ISLE OF ANGLESEY COUNTY COUNCIL	
Report to	County Council
Date	24 January 2013
Subject	SPG Onshore Wind Energy
Portfolio Holder(s)	Councillor R. Ll. Hughes
Lead Officer(s)	Mr Jim Woodcock Head of Planning & Public Protection Service
Contact Officer (s)	Gwyndaf Jones Chief Planning Officer 01248 752 403 and Bob Thomas (Team Leader) Joint Planning Policy Unit 01286 685 000
Nature and reason for reporting	
<p>The Council has prepared a SPG regarding development that involve onshore wind energy development that was revised following the first public consultation period, which was then subject to another public consultation period. This report sets out the recommended response to the representations that were received and seeks the Council's approval of the recommended responses and the changes to the SPG</p>

CH - Summary
<p>The report and its appendix provide a detailed response to the public consultation about the revised SPG. A third revised SPG showing the recommended changes has been prepared in response to representations made and is presented in Appendix 2</p>

Map 1 – Strategic Assessment 21m to tip height

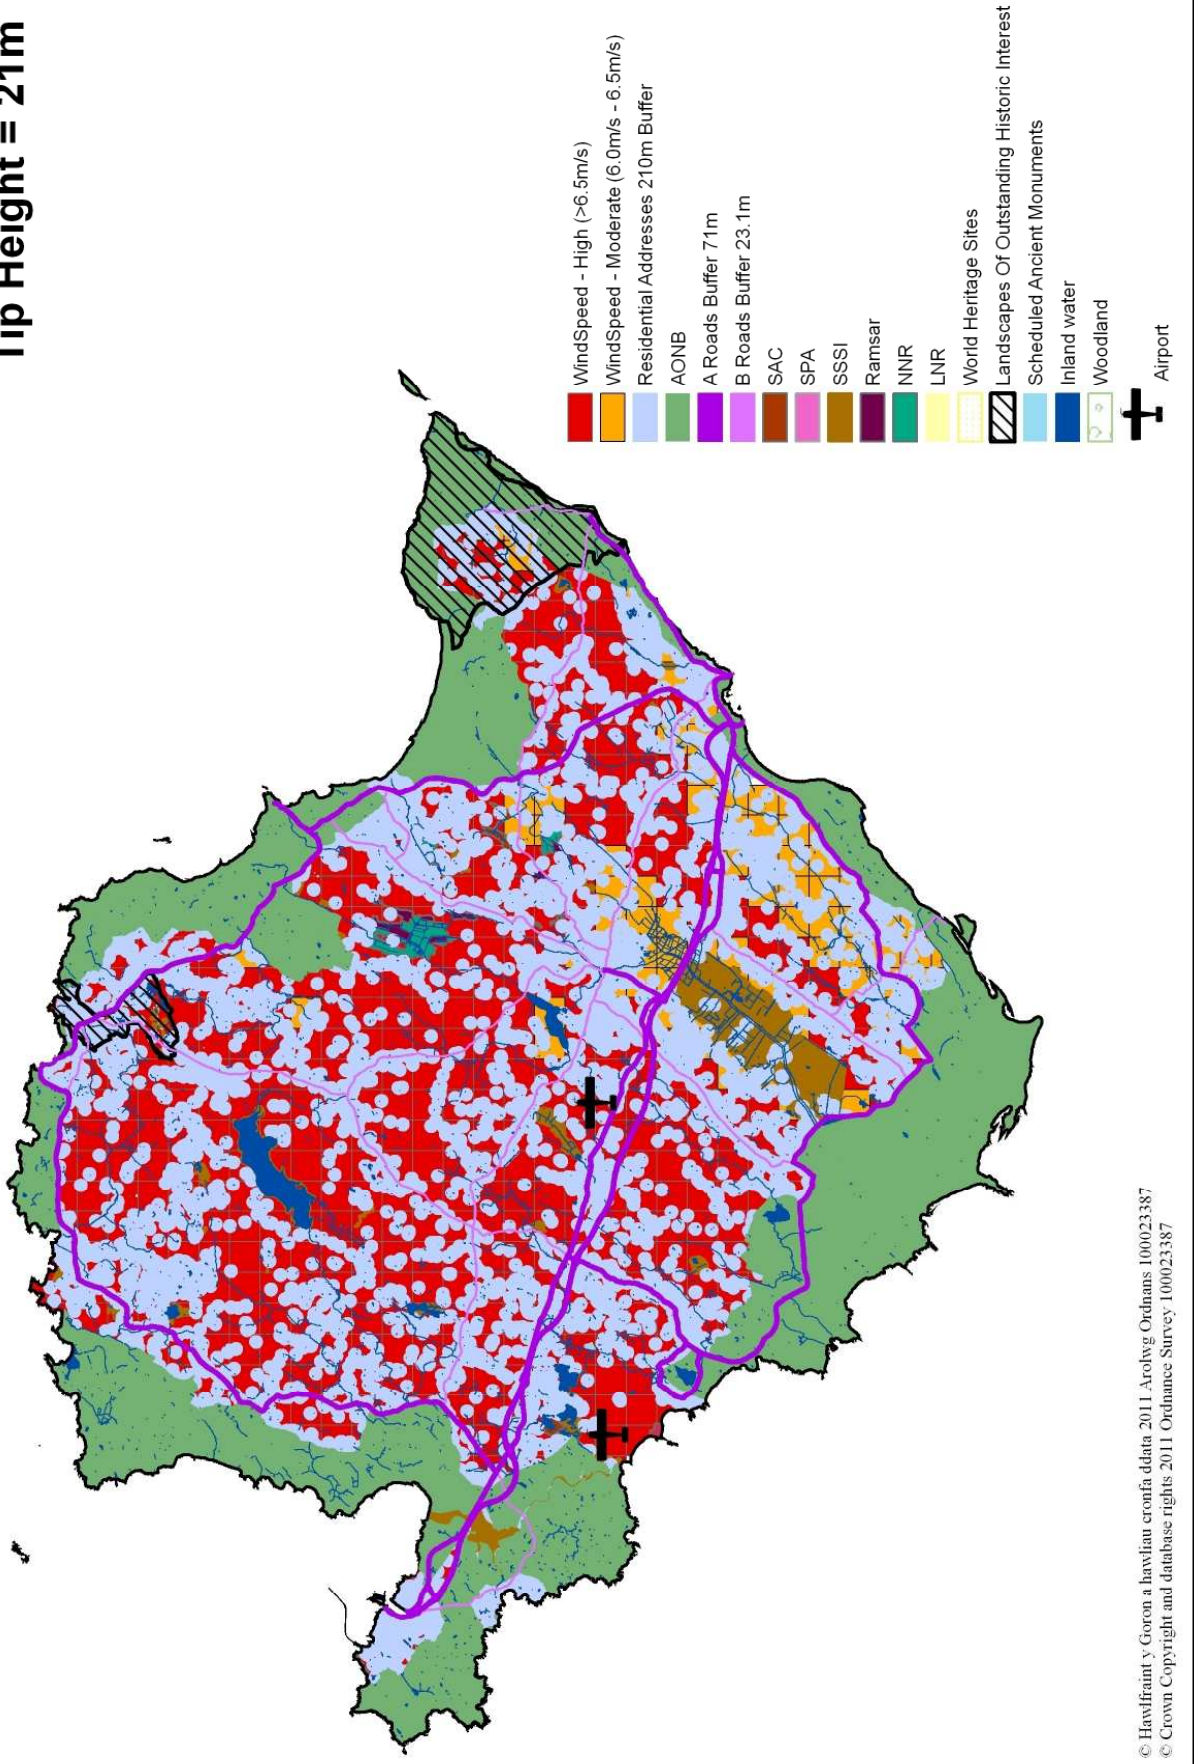
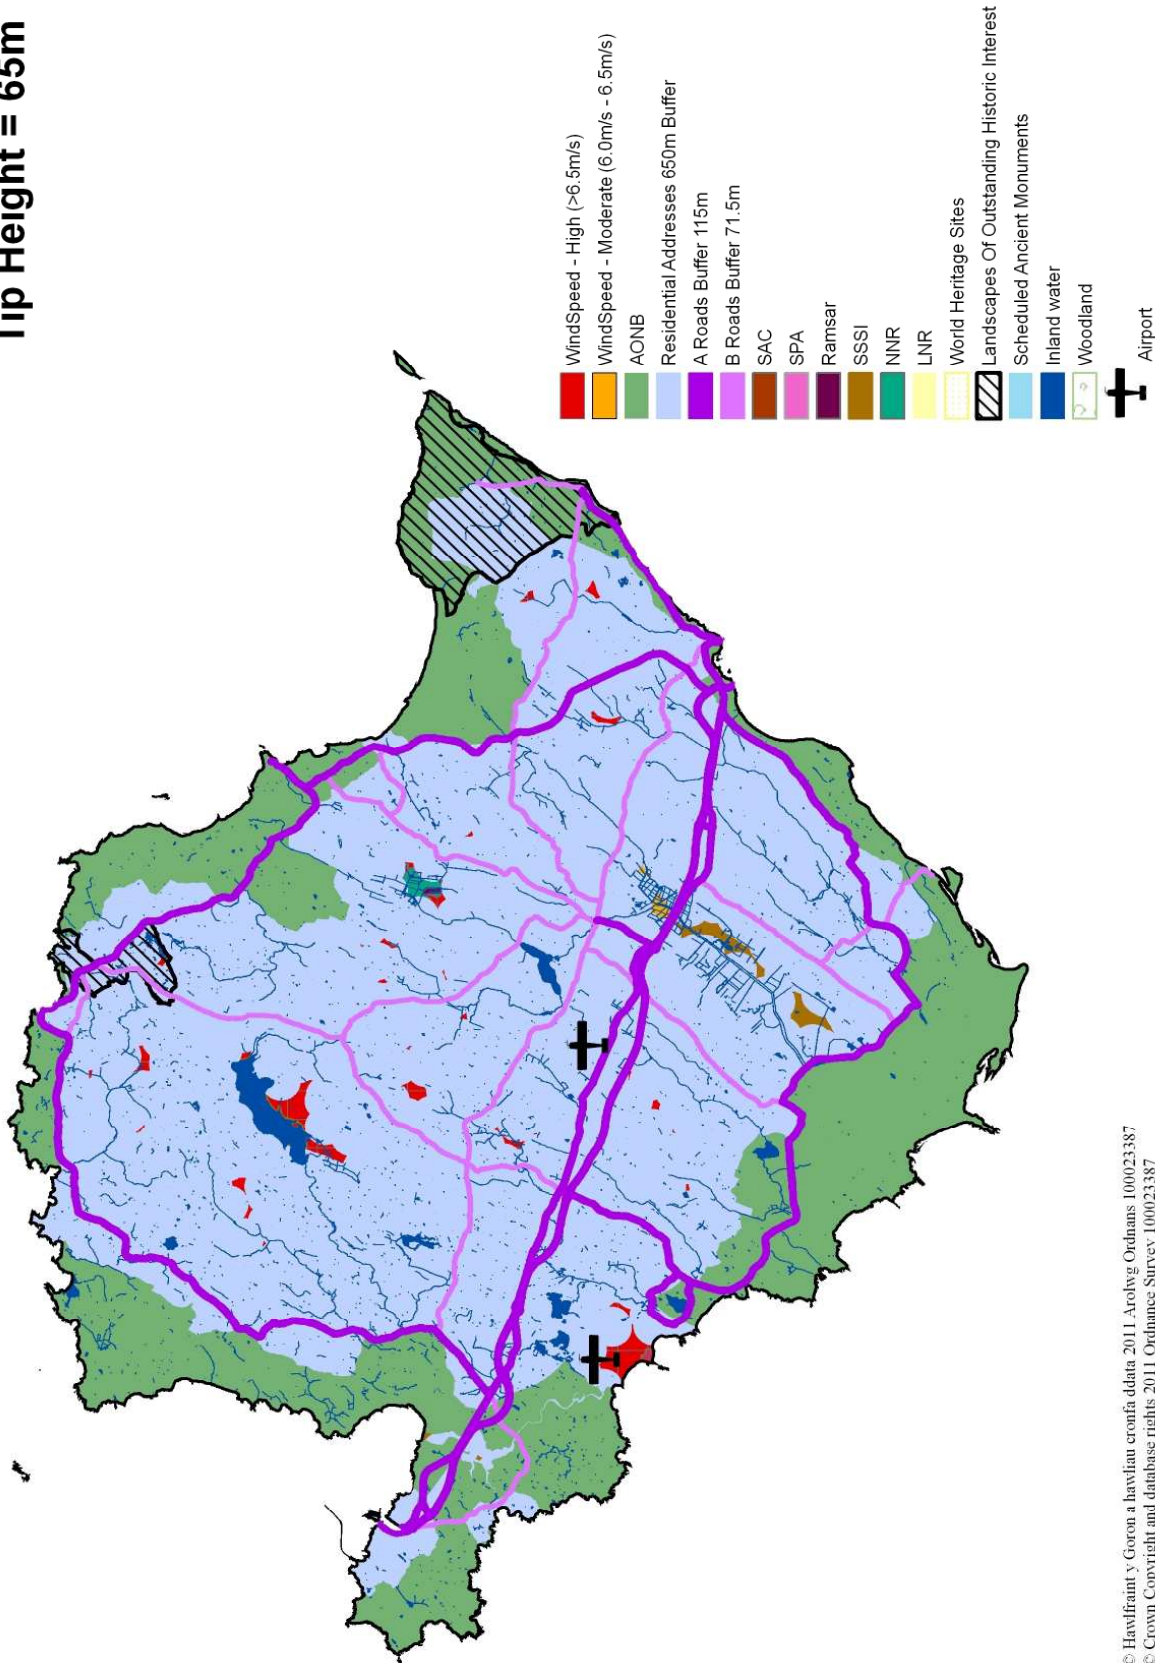
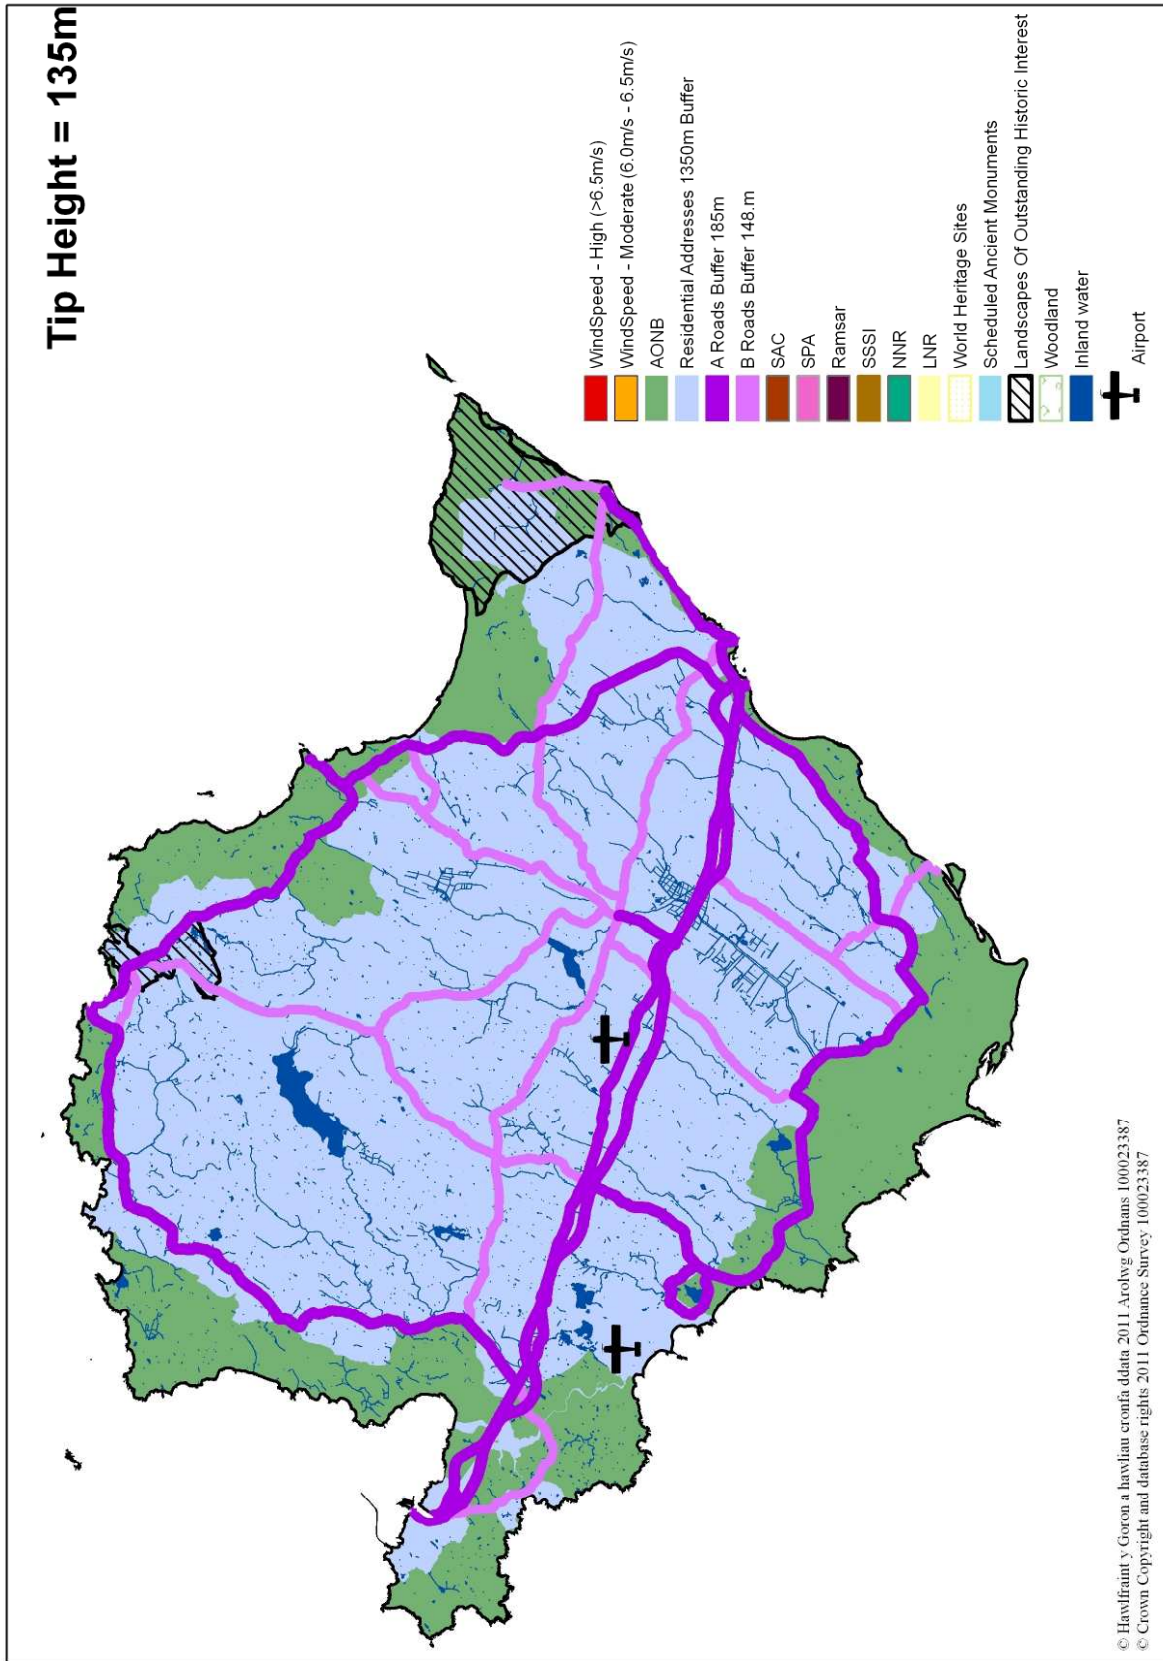
AY108	5	5.12 and Maps 1 - 3	Maps to include a buffer zone around the AONB and all SACs/SPAs/SSSI.	to address the requirements of Regulation 39 of the Conservation Regulations 2010	Regulation 39 of The Conservation of Habitats and Species Regulations 2010 refers to nature conservation in planning contexts and requires land use policies on development and use of land and conservation to take into consideration the need to encourage the management of landscape features which are of importance to wild fauna and flora. Will apply to new LDP not existing policy framework. Does not include reference to buffer zones	No change
AY116	5	5.2	There should be a buffer zone around AONB in which no turbines greater than 20 metre high are allowed. This buffer zone should be 2km wide or greater.	No evidence to support comment submitted	No specific evidence submitted in support of the comment made	No change
AY118		5.2.3 7.9	Call for no commercial wind turbines in any Area of Outstanding Natural Beauty and National Parks and a minimum of 1.5km separation distance between any commercial wind turbine development and residential properties, Heritage Sites, Listed Buildings and Historic Monument Site or Sites.	No evidence to support comment submitted	No specific evidence submitted in support of the comment made	No change

Diagram 1

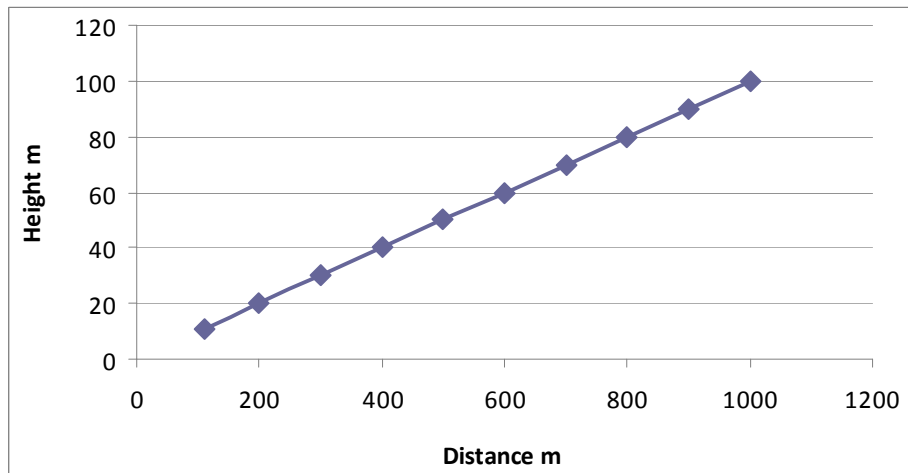
AY045		5.2.3 7.9				
AY046		5.2.3 7.9				
AY049		7.9.8	At the very least, the 500 meter separation should be adhered to, with table 4 imposed on top, i.e. small turbine 11.1m — 20m tip separation distance should be 611 meters — 700 meters.	No evidence offered in support of statement	No specific evidence submitted in support of the comment made	No Change
AY050		7.9.8				
AY051		7.9.8				
AY052		7.9.8				
AY055		7.9.8/7.9.9	Paras 7.9.8 – 7.9.9 are misleading and it is suggested that they should either be deleted or at the very least re-worded. Use of the term "minimum separation distances" in these paragraphs is very misleading and will lead to confusion	Whilst WCE have no objection to the inclusion of some sort of trigger mechanism for providing a RAA, it should clearly be termed as such and not referred to as a "minimum separation distance". This is misleading to any reader of the guidance – including developers, Councillors, and members of the public.	Agree that this could be misleading.	Amend to exclude reference to minimum distances

AY079		7.9.8	At the very least, the 500 meter separation should be adhered to, with table 4 imposed on top, i.e. small turbine 11.1m — 20m tip separation distance should be 611 meters — 700 meters.	No evidence offered in support of statement	No specific evidence submitted in support of the comment made	No Change
AY080	7	7.9	In response to the consultation we the undersigned call for a 1.5km separation distance between any commercial wind turbine development and residential properties.	No evidence offered in support of statement	No specific evidence submitted in support of the comment made	No Change
AY081		5.2.3 7.9	We support the AAWT petition calling for no commercial wind turbines in the AONB and a minimum of 1.5 KM separation distance between any commercial wind turbine development and residential properties.	No evidence offered in support of statement	No specific evidence submitted in support of the comment made	No Change
